TM 11-5820-398-35

RADIO SET AN/PRC-25

CHANGE }
No. 1 }

HEADQUARTERS
DEPARTMENT OF THE ARMY
WASHINGTON, D.C., 17 September 1964

Figure 68.1. Module A16, late model, parts location.

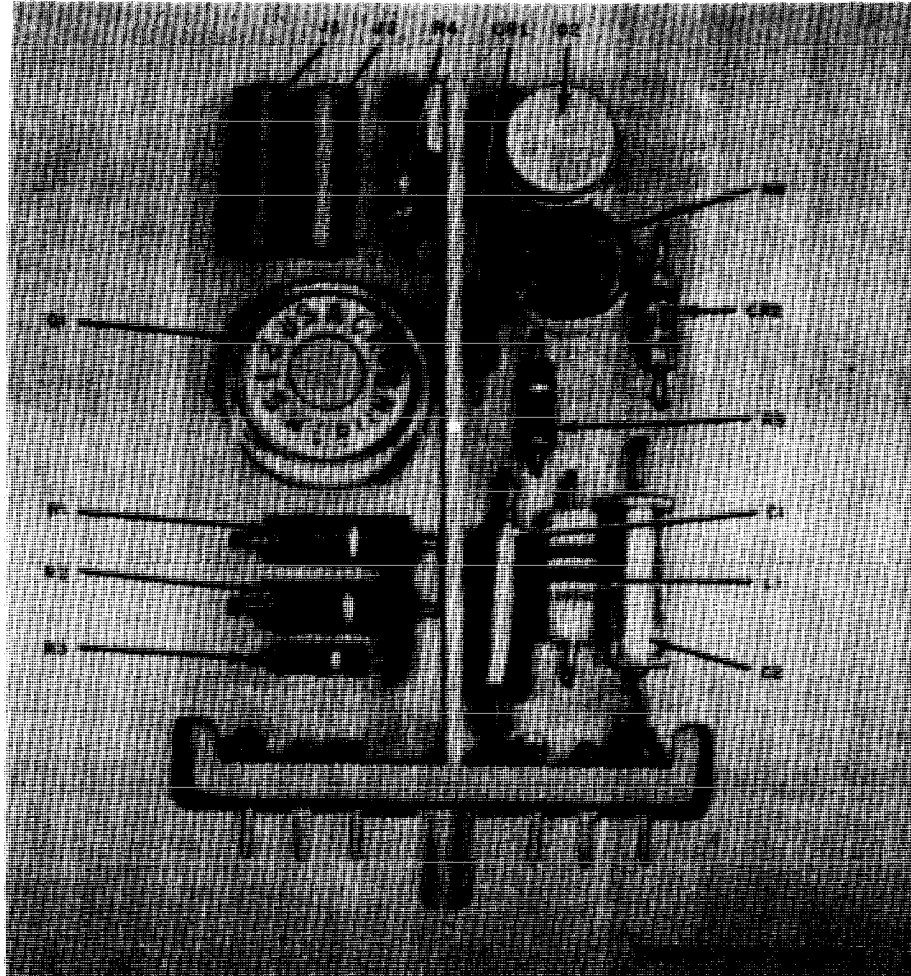
- (5) If the voltage measured in (3) above is incorrect in a late model module A16, adjust R6 (fig. 68.1) for the correct output voltage.

Figure 68, caption. Change the caption to:
Module A16, early model, parts location.

Add figure 68.1 after figure 68.

Figure 70.1. Module A18, late model, parts location.

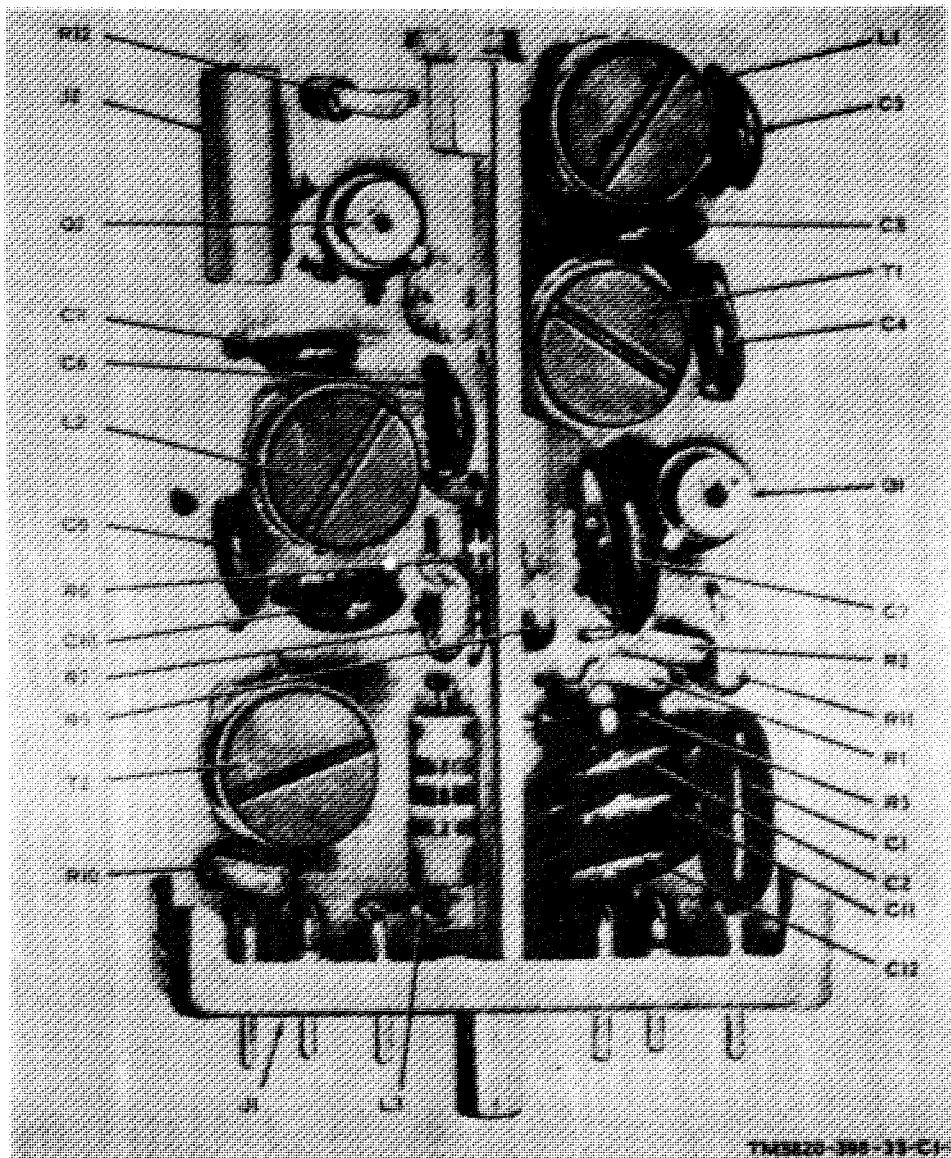
Page 135, figure 70, caption. Change the figure caption to: *Module A18, early model, parts location.*

Add figure 70.1 after figure 70.

Figure 75. Module A23, early model, parts location.

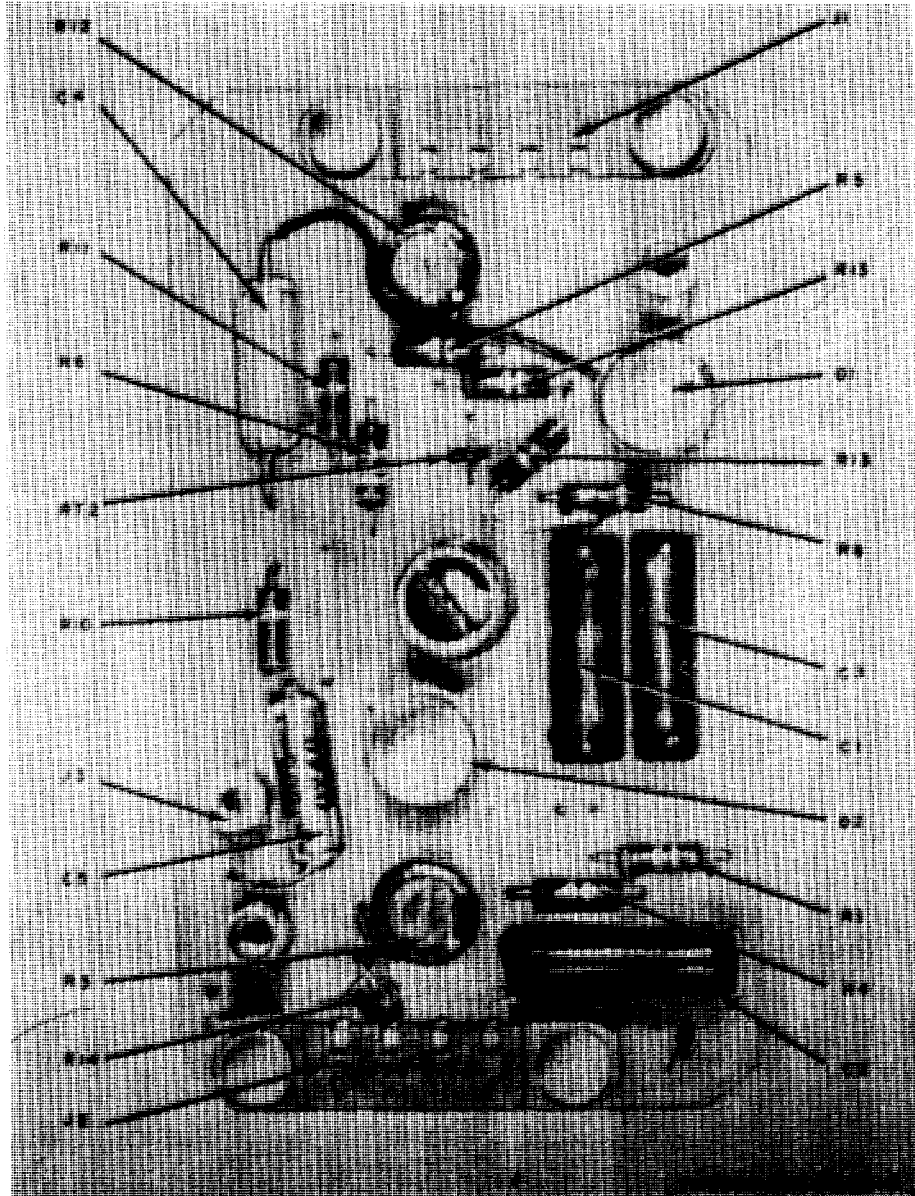
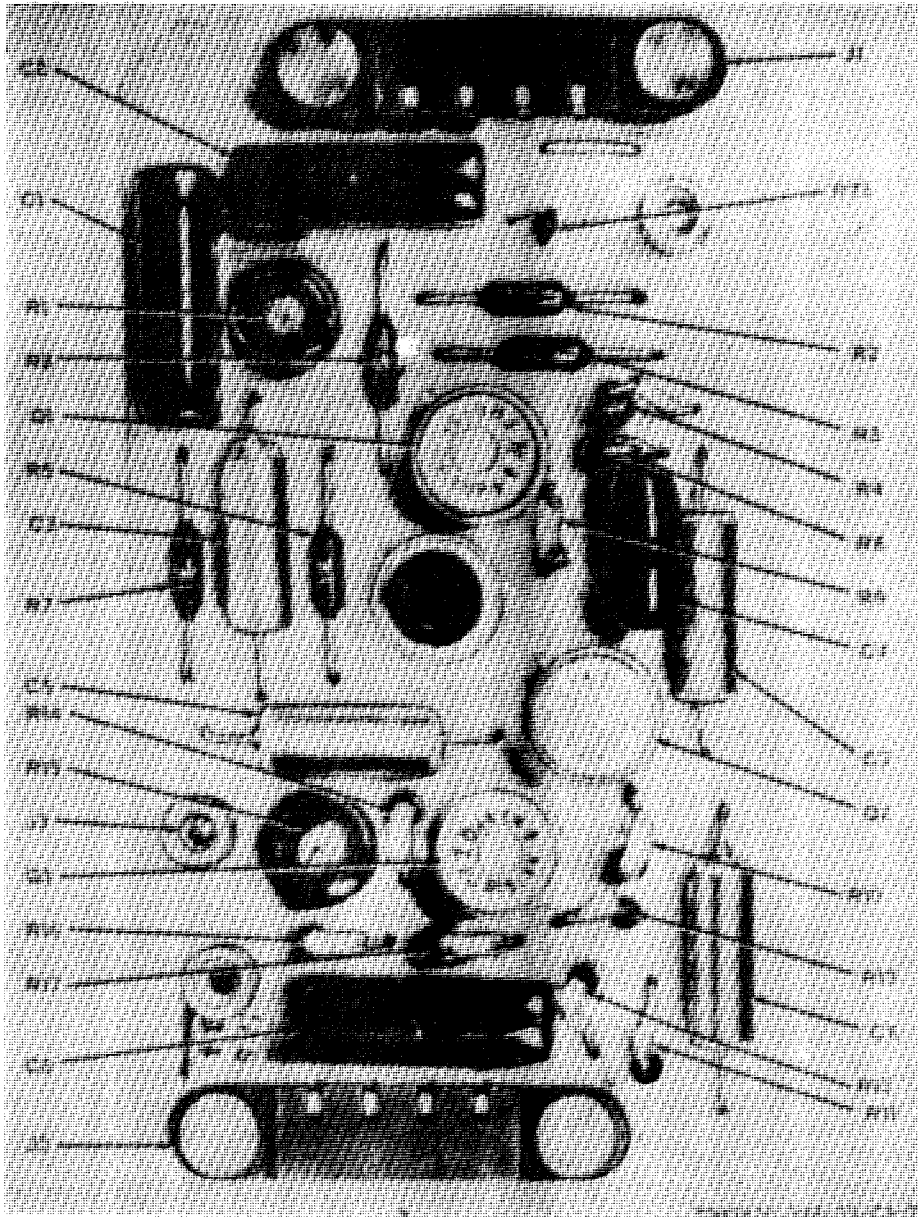
Page 142, figure 75. Delete figure 75 and substitute new figure 75.

Add figure 75.1 after figure 75.

Figure 61.1. Module A9, Order No. 64009-PP-63, improved module, parts location.

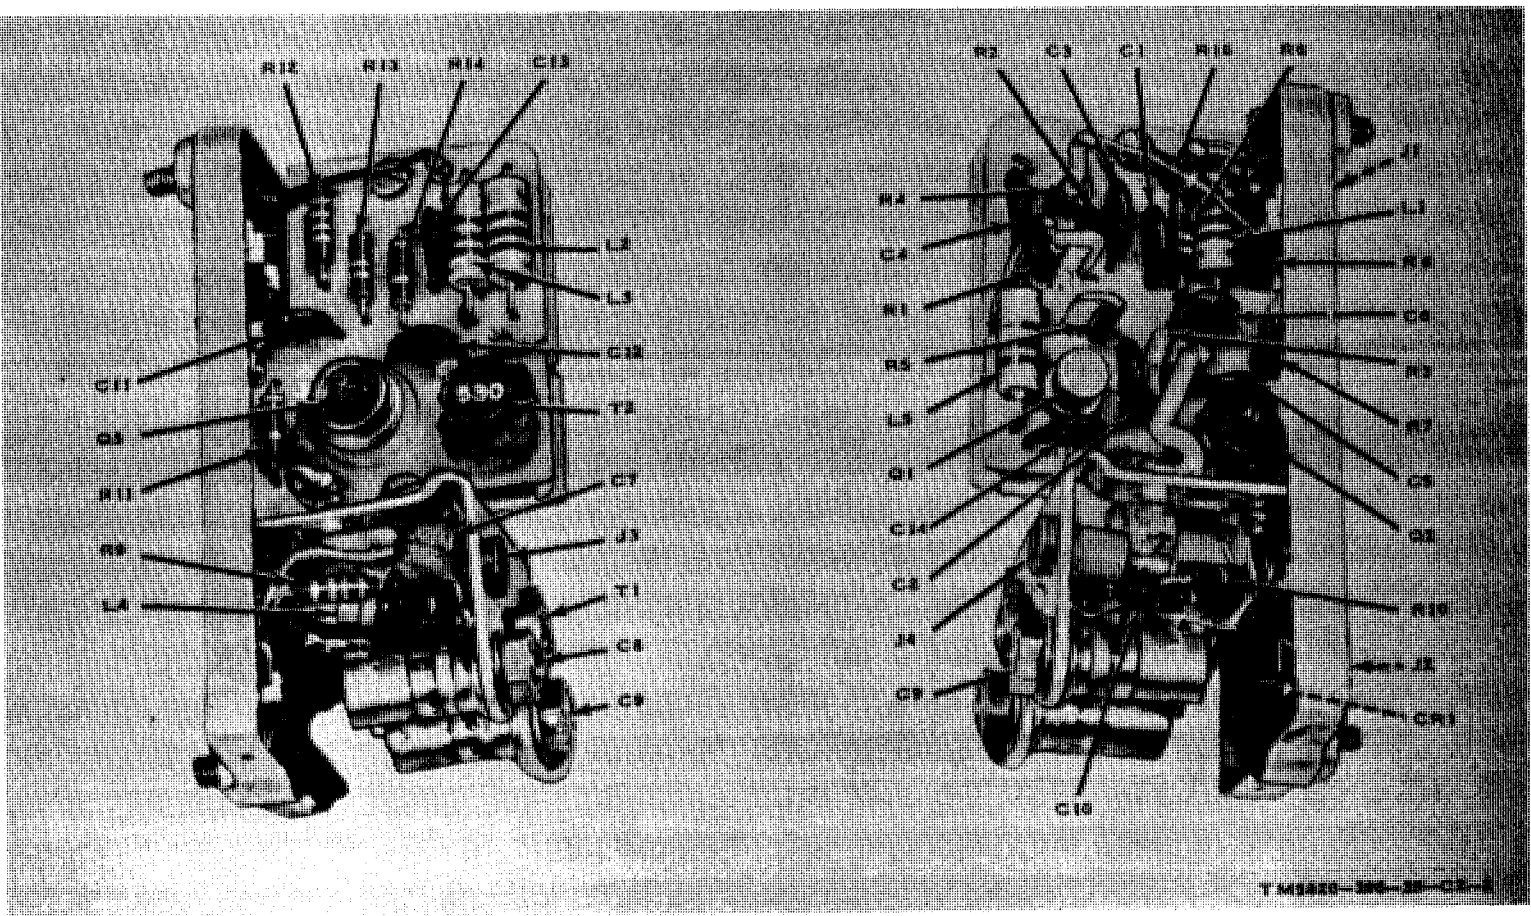
Step No. 1: Change 2 watts to 1.6 watts.

2: Change 1.5 watts to 1.1 watts.

Figure 1. First rf amplifier module A3, schematic diagram.

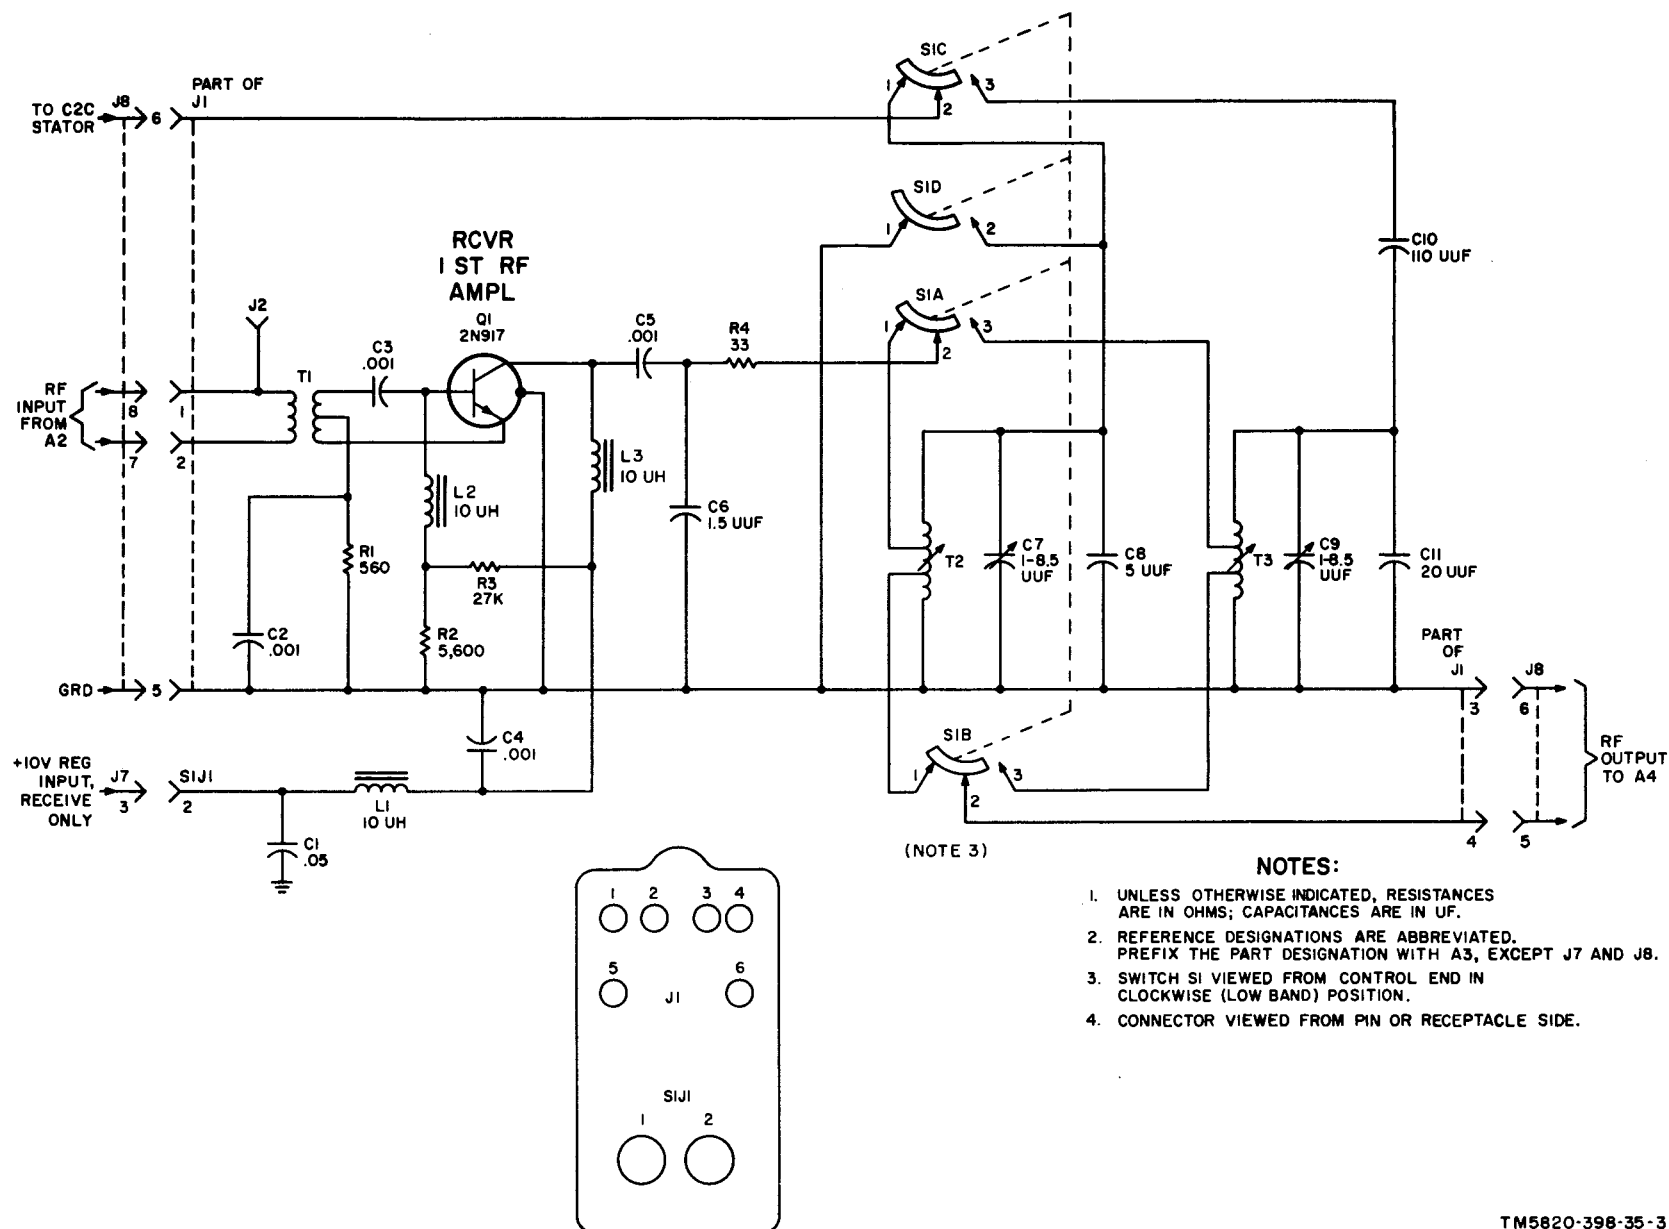
Page 9, figure 1. Make the following changes:

Near C10, add: (NOTE 5).

Near L2, add: (NOTE 6).

5. IN LATE MODELS, THE VALUE OF C10 IS 120 UUF.

6. IN LATE MODELS, L2 IS REPLACED WITH A 33-OHM RESISTOR, R5.

Figure 2. Second rf amplifier module A4, schematic diagram.

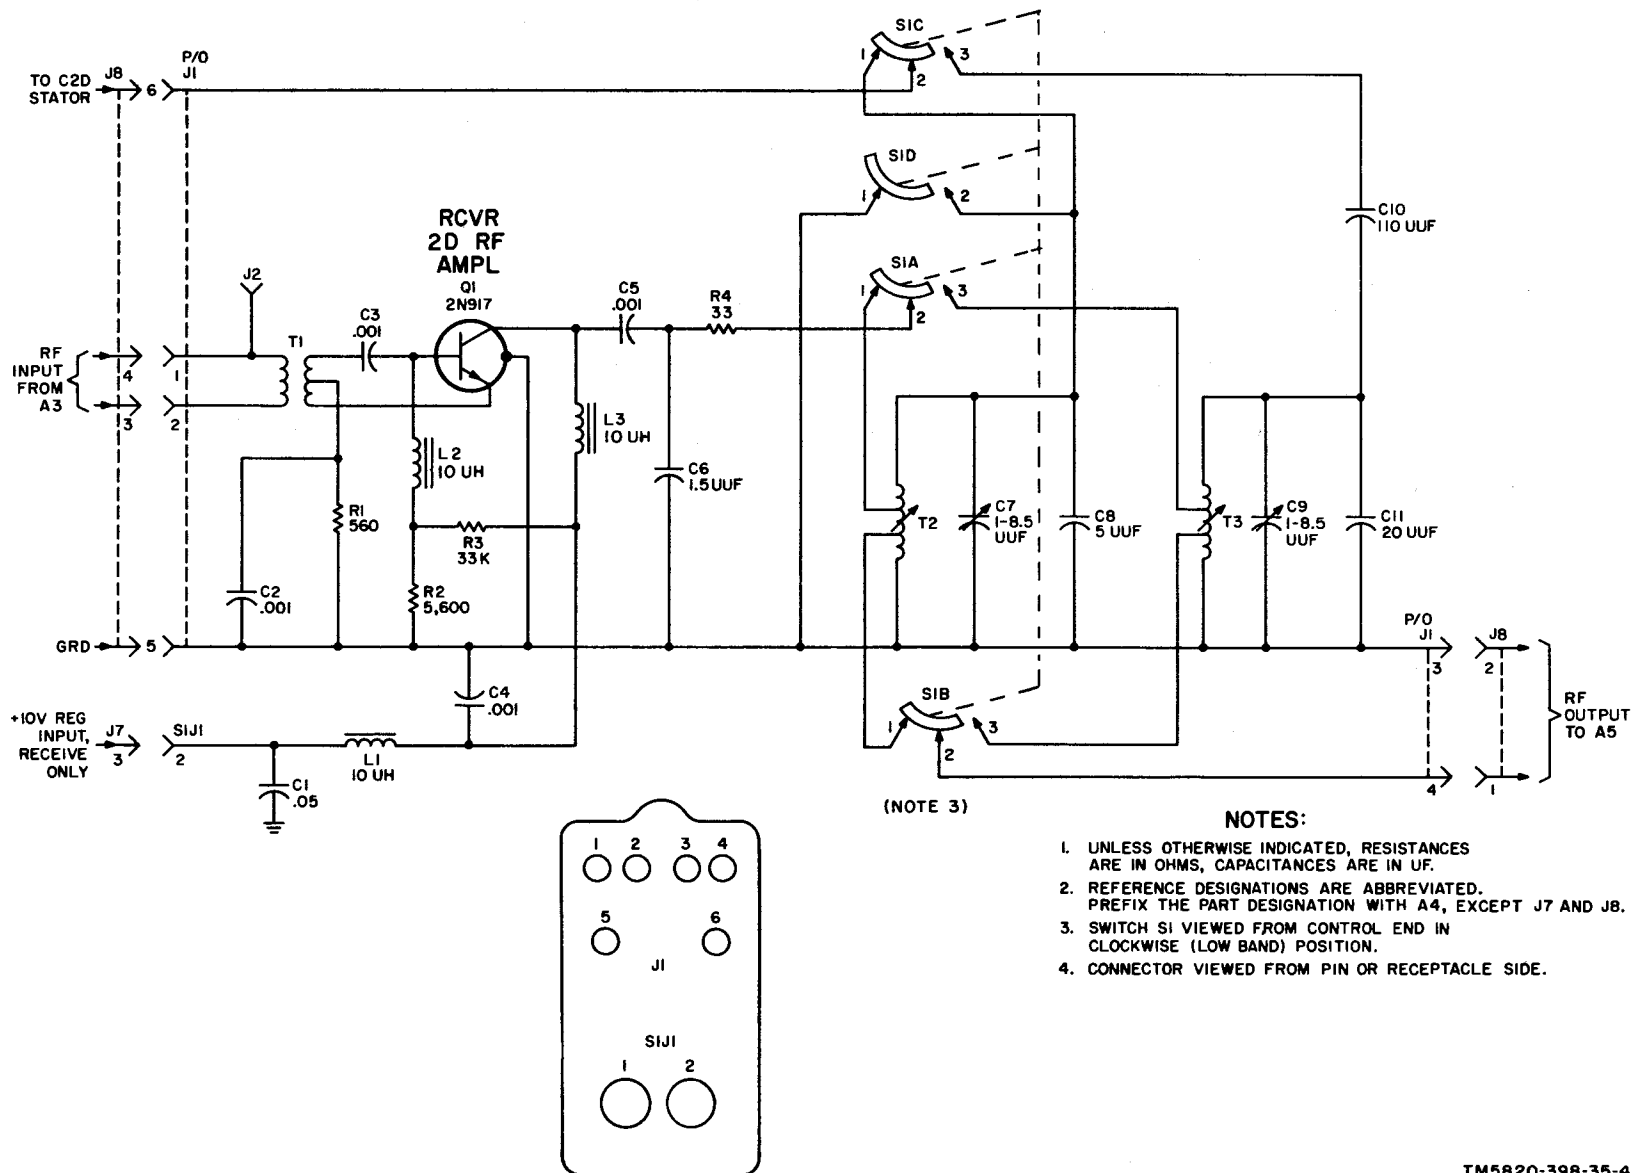
Page 10, figure 2. Make the following changes:

Near L2, add: (NOTE 5).

Page 10, figure 2 (page 1 of C 1). After note 5, add note 6.

Figure 3. Receiver mixer module A5, schematic diagram.

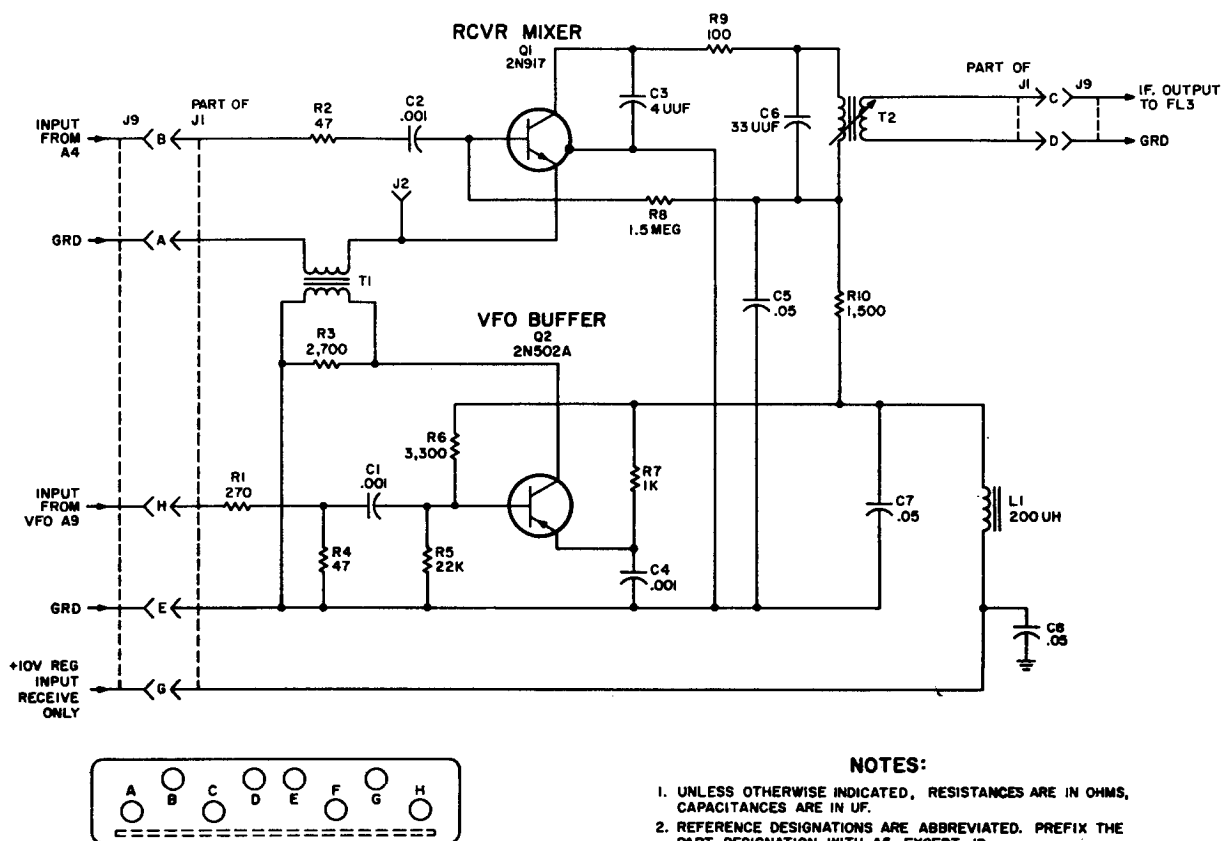
Page 11, figure 3. Make the following changes:

Change the value of R1 from 270 to 10 ohms.

Near R3, add: (NOTE 4).

Near R4, add: (NOTE 5).

Page 11, figure 3 (page 1 of C 1). After note 5, add note 6.

6. IN LATER EQUIPMENT BEARING ORDER NO. 64009-PP-63, R4 IS 68 0HM3 AND A MODULE GROUND STRAP HAS BEEN ADDED.
